BUILDING PERMIT RECEIPT

Proposed Clay Electric District Office
SW S.R. 47
Lake City, Columbia County Florida

Proposed Clay Electric District Office
SW S.R. 47

ELECTRICAL SITE PLAN

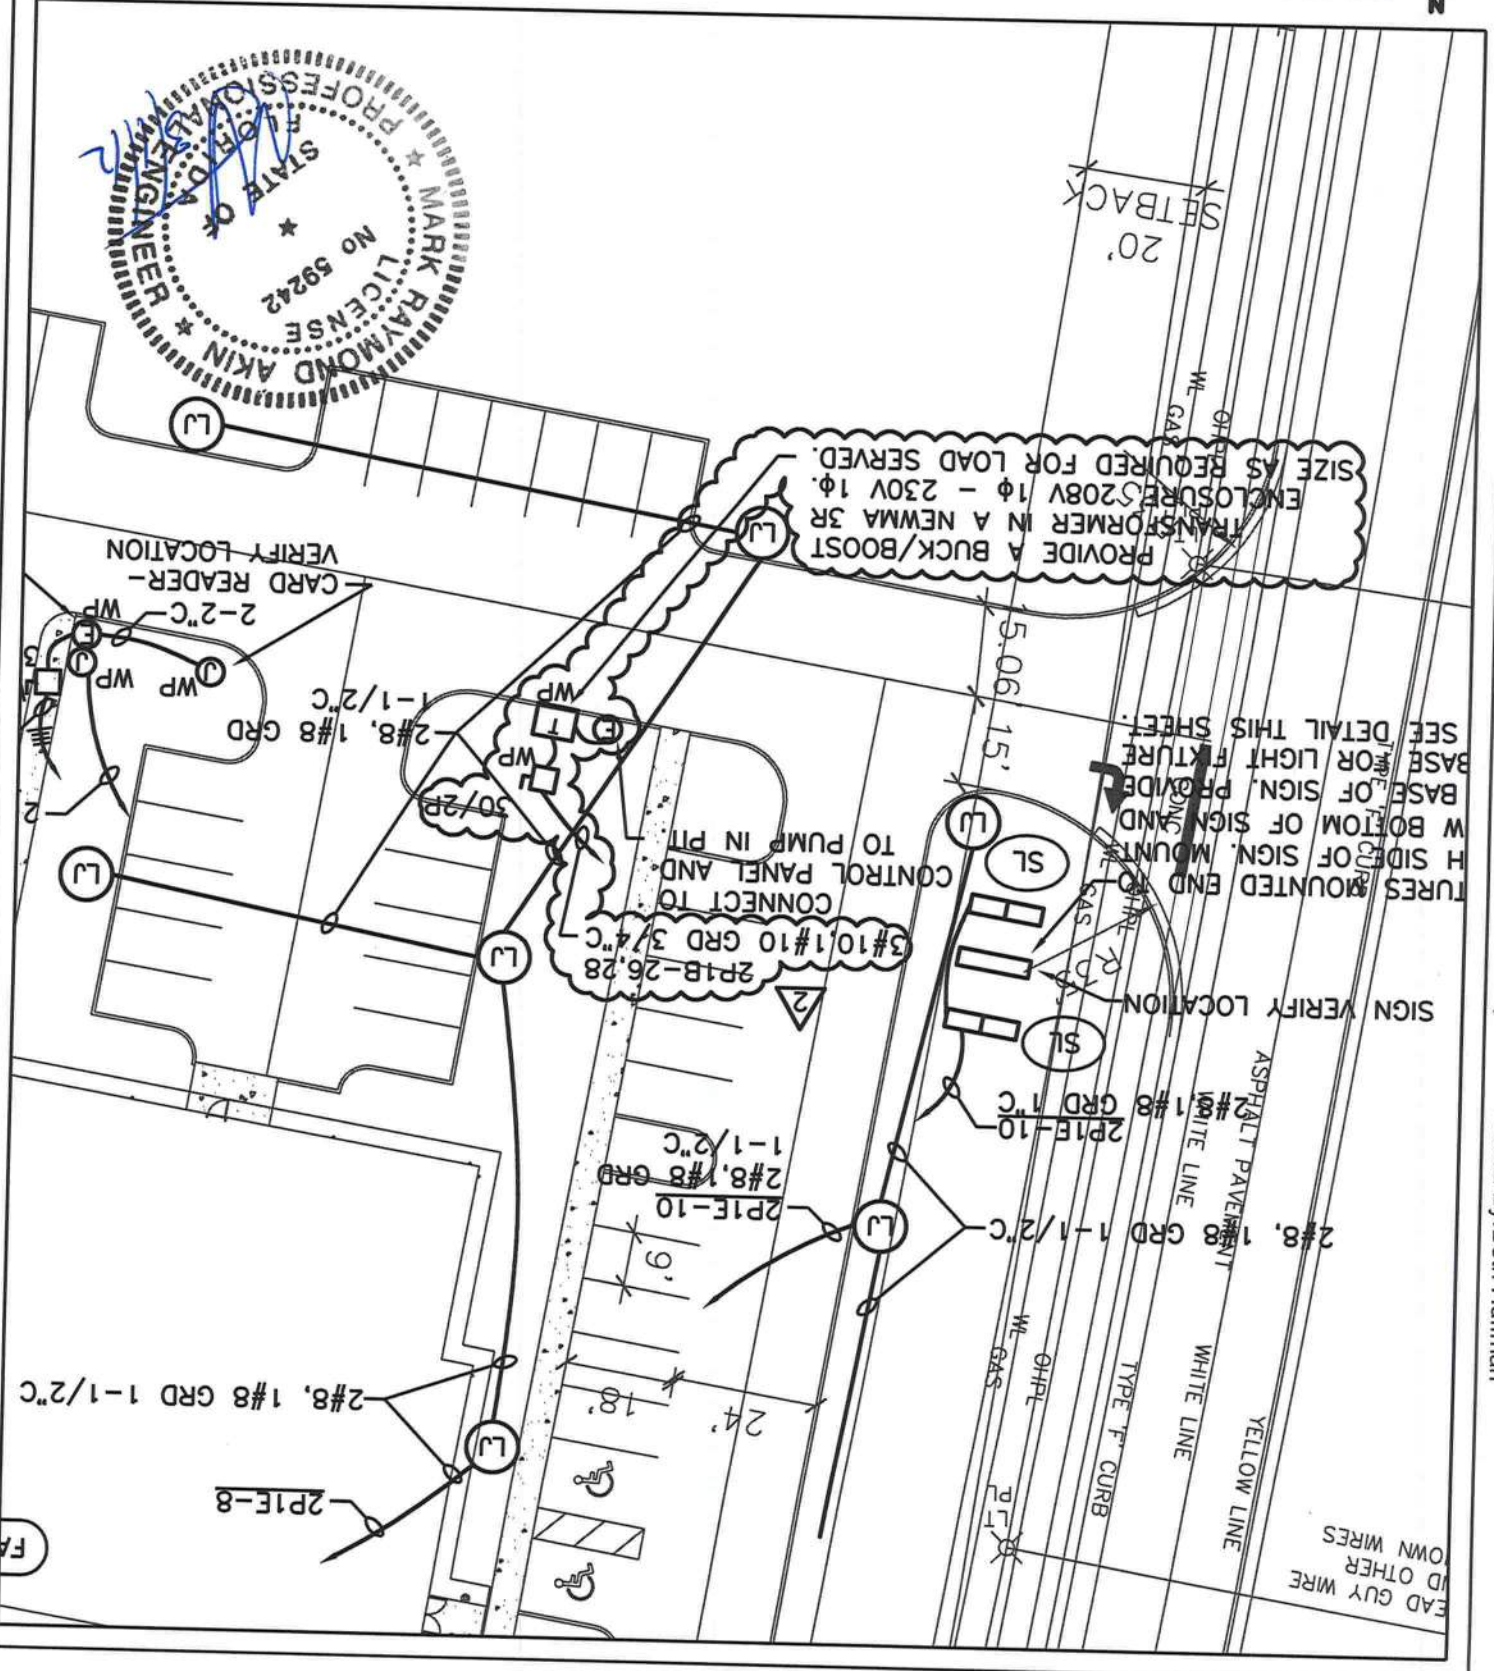
Item 16 ELECTRICAL SITE PLAN, revise as shown in the attached supplemental drawing E0.2a dated February 20, 2012.

PARTIAL FLOOR PLAN

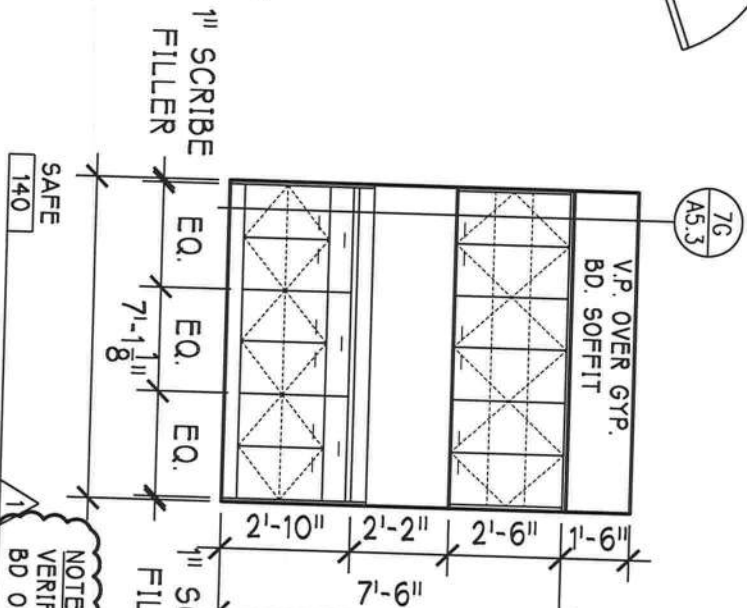
FLOOR PLAN, Safe 140, revise as indicated on the Drawing SK-5, PARTIAL FLOOR PLAN, dated 02/21/12.

INTERIOR ELEVATIONS

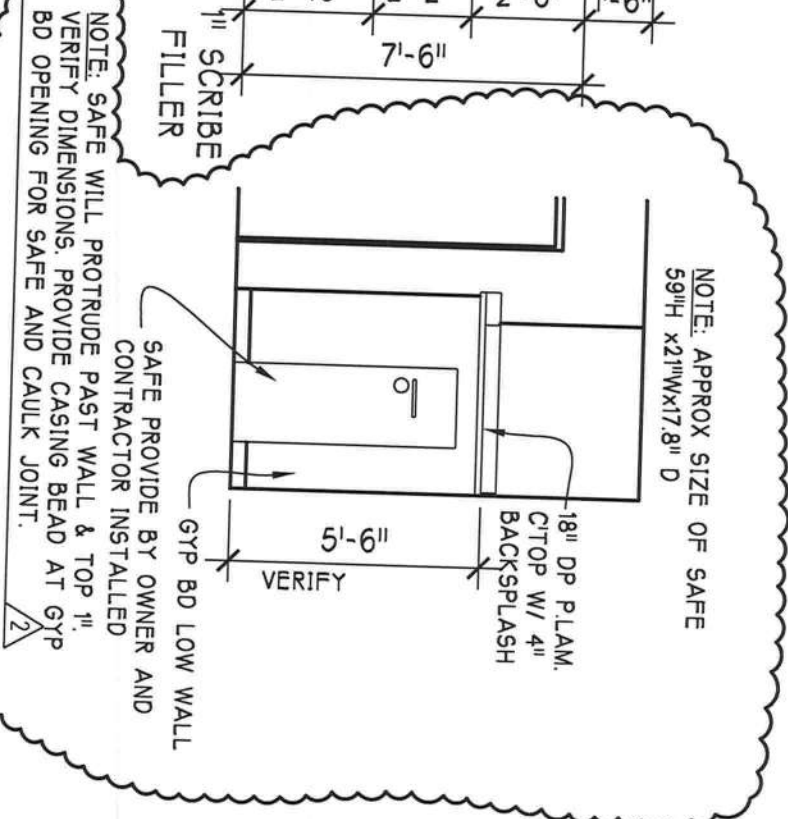
INTERIOR ELEVATIONS, Safe 104, revise Elevation 2 as indicated on the attached Drawing SK-5, dated 02/21/12.
